Item 2

6 Delmar Parade, Gladesville

Partial demolition of an existing dwelling, construction of a two-storey dwelling, retention of the garage, and associated landscaping

**City of Ryde
Local Planning Panel Report**

Figure 16 – 3.00pm

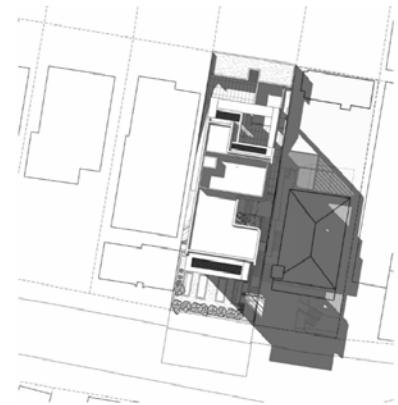
“Shadow diagrams are submitted with the DA plan set. The diagrams demonstrate that neighbouring properties to the east, west and south of the site will continue to receive 3 hours of solar access to northern living room windows and the rear private open space.

Figure 17 – Provision of deep soil area.

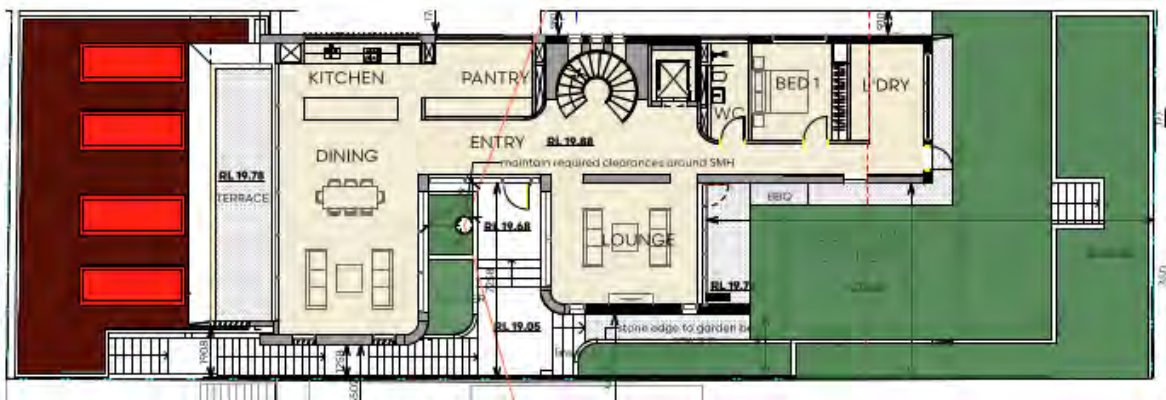
Figure 17 below shows the area (shaded in green) which is assessed as deep soil area. The area shaded in red is proposed to comprise a green roof above the garage however, this area fails to provide sufficient soil depth to qualify as deep soil area.

As seen in **Figure 17** above, notwithstanding the retaining wall which terraces the rear yard, the development provides a continuous area of 7.26m x 15m (i.e. 108.9m²) which exceeds the area required despite not meeting the minimum dimension.

Figure 19 – Non-compliant wall plate height at the western elevation.

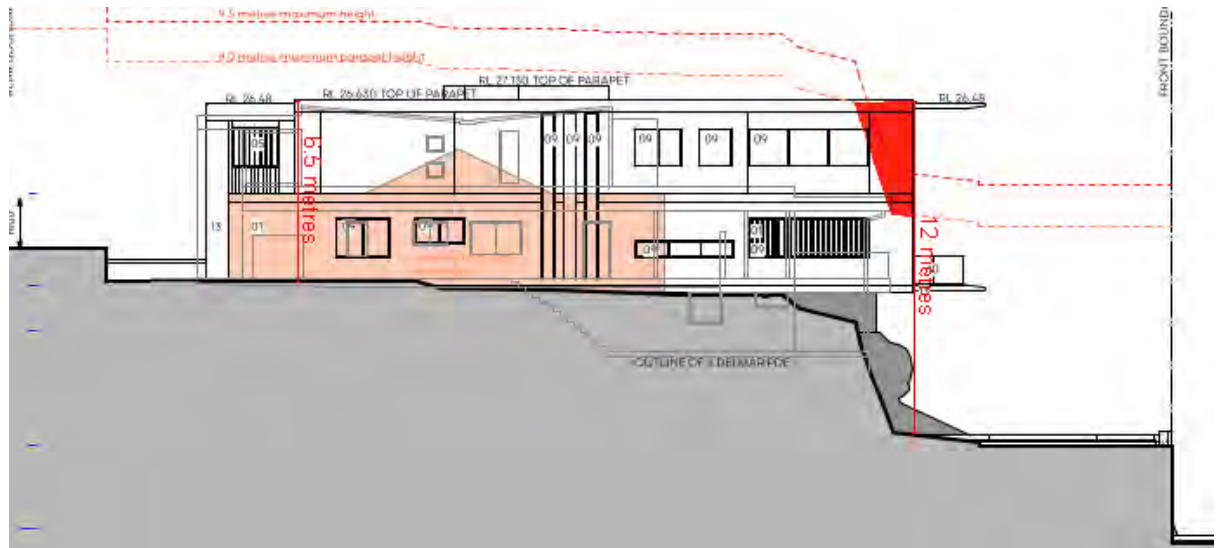
The development provides a wall plate height of between 7.05m and 12.5m. As seen in **Figures 18 and 19** below (as shaded in red), the non-compliant elements are located at the front of the dwelling at both the east and west side elevations.

Figure 26 – Approved garage.

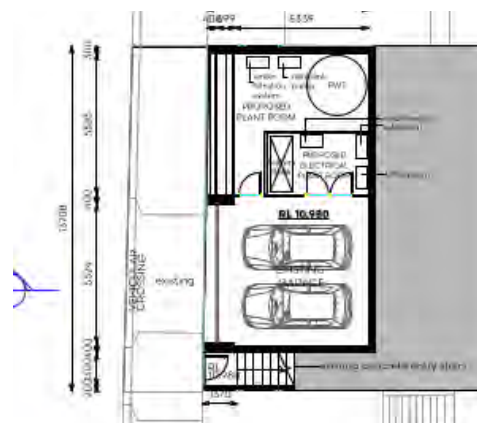
The development proposes to retain the garage in-situ and change the arrangement and purpose of the interior western side from a workshop/storage area to a plant room. **Figures 26 and 27** below show the approved and modified garage.

Despite the non-compliance, this application does not seek to change or enlarge the garage and therefore, while the non-compliance is acknowledged, the retention of the garage in situ is supported.

Figure 28 – Front setback alignment (depicted by the orange line).

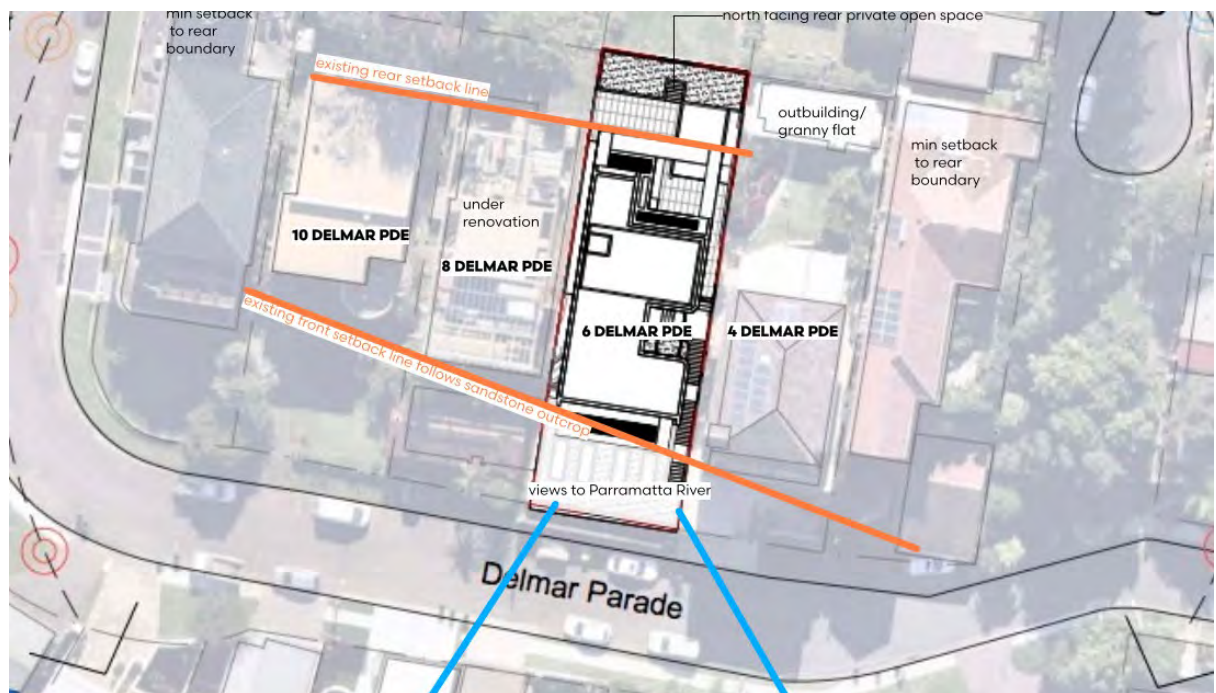
With regard to the building setback of the dwelling, as noted earlier this complies with the setback requirement of Clause 2.9.1. However, it is worth noting that the positioning of the frontage of the dwelling is at an approximate average between 4 Delmar Parade and 4 Delmar Parade as illustrated in **Figure 28** below, and in **Figures 21 to 24** previously.

Figure 29 – Non-compliant side setbacks at the ground floor level.

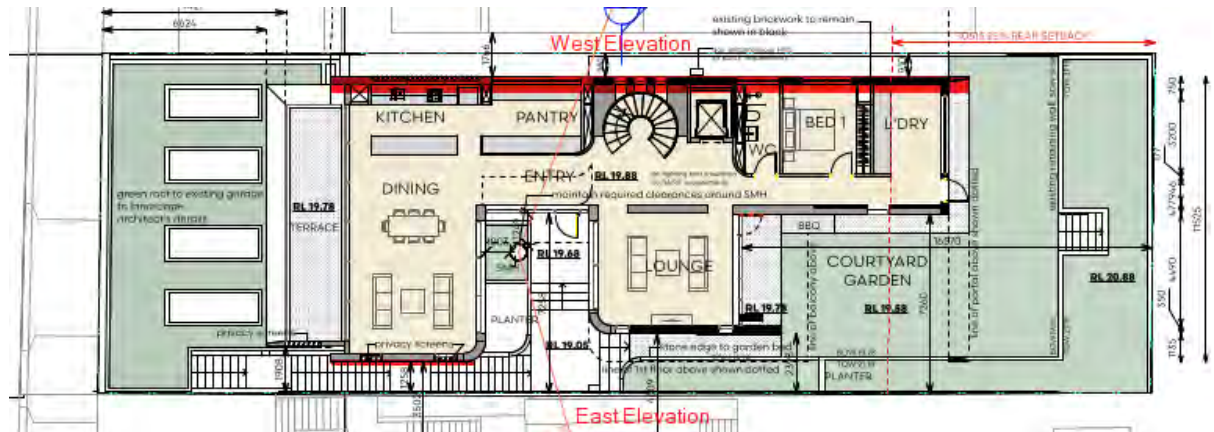
Elevation/Level	Setback	Variation
East/Ground	1.258m to 7.26m	16.1% (-0.242m)
East/Upper	1.258m to 6.108m	16.1% (-0.242m)
West/Ground	0.91m	39.3% (-0.59m)
West/Upper	0.91m to 1.5m	39.3% (-0.59m)

Figures 29 and 30 show the areas of non-compliance (shaded in red which indicate the required setback of 1.5m).

Figure 31 – Non-compliant rear setbacks at the ground floor level.

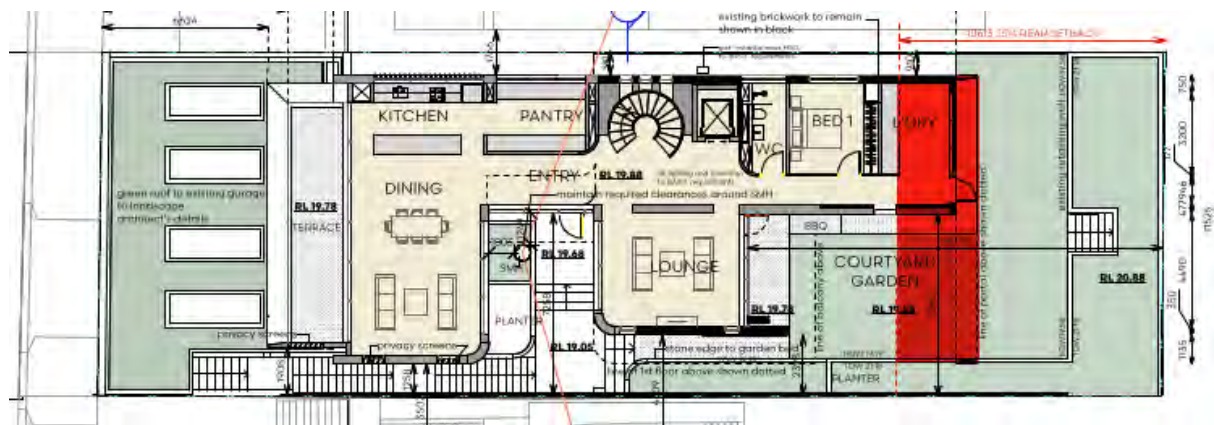
Element	Proposed Rear Setback	Compliance
Rear Screen	7.5m	No 29.4% (-3.13m)
Rear Ground Floor		
Terrace	7.5m to 14.9m	No 29.4% (-3.13m)
Dwelling	8.2m to 16.6m	No 22.8% (-2.43m)
Rear First Floor		
Balcony	10.1m to 14.2m	No 4.9% (-0.53m)
Dwelling	11.3m to 15.4m	Yes

Figures 31 and 32 below show the non-compliant elements (note that the non-compliant elements listed above are contained within the red shaded area which depicts the extent of the rear screen).

Figure 38 – The same view angles from 8 Delmar Parade (expanded).

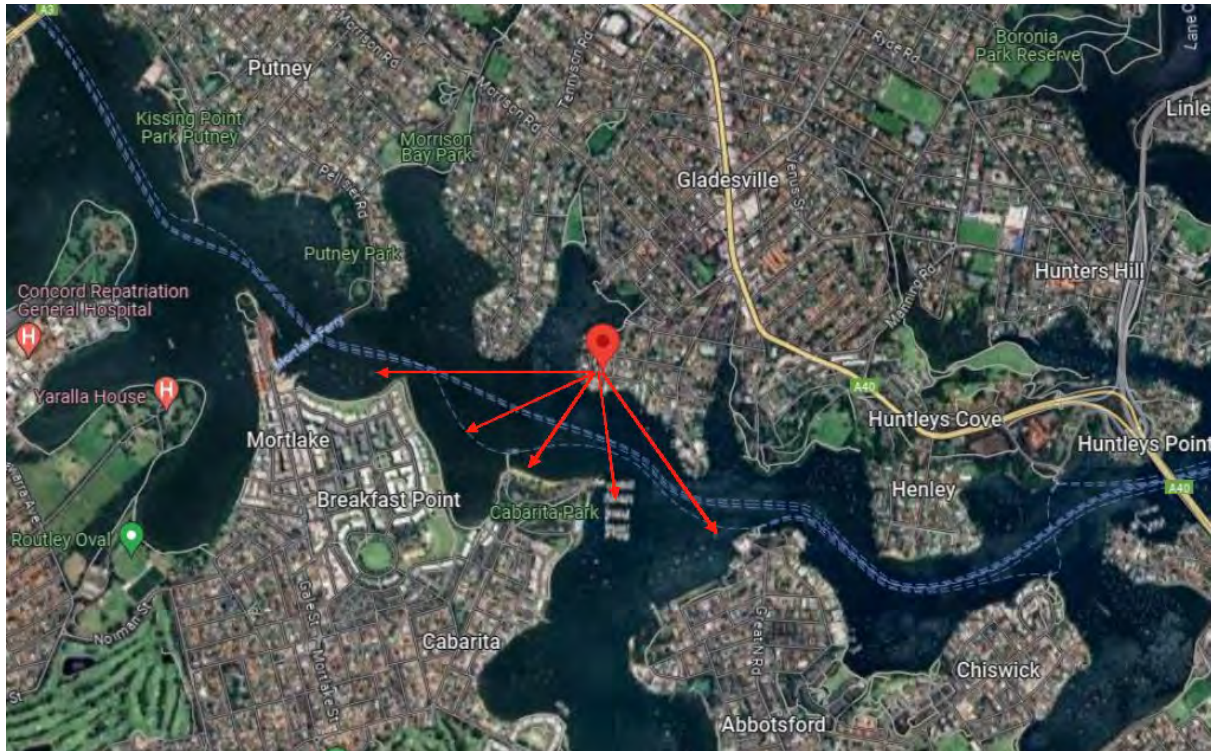
Figure 37 below shows the view angles available from the front terrace of 8 Delmar Parade. As can be seen, by virtue of its location and elevated position, 8 Delmar Parade currently enjoys sweeping district and water views from the south-east (indicated by the red dashed line) to the west. **Figure 37** also shows the location of 42, 44 and 46 Amiens Street to the north.

The development would reduce the south-east view angle by approximately 30° however, as can be seen in **Figure 38**, the remaining district and water views from the south/south-east to the west are unaffected.

As seen in **Figure 37 and 38** and in **Figures 39 to 42**, the extent of impact is a 30° cone across the south-eastern side of the property.
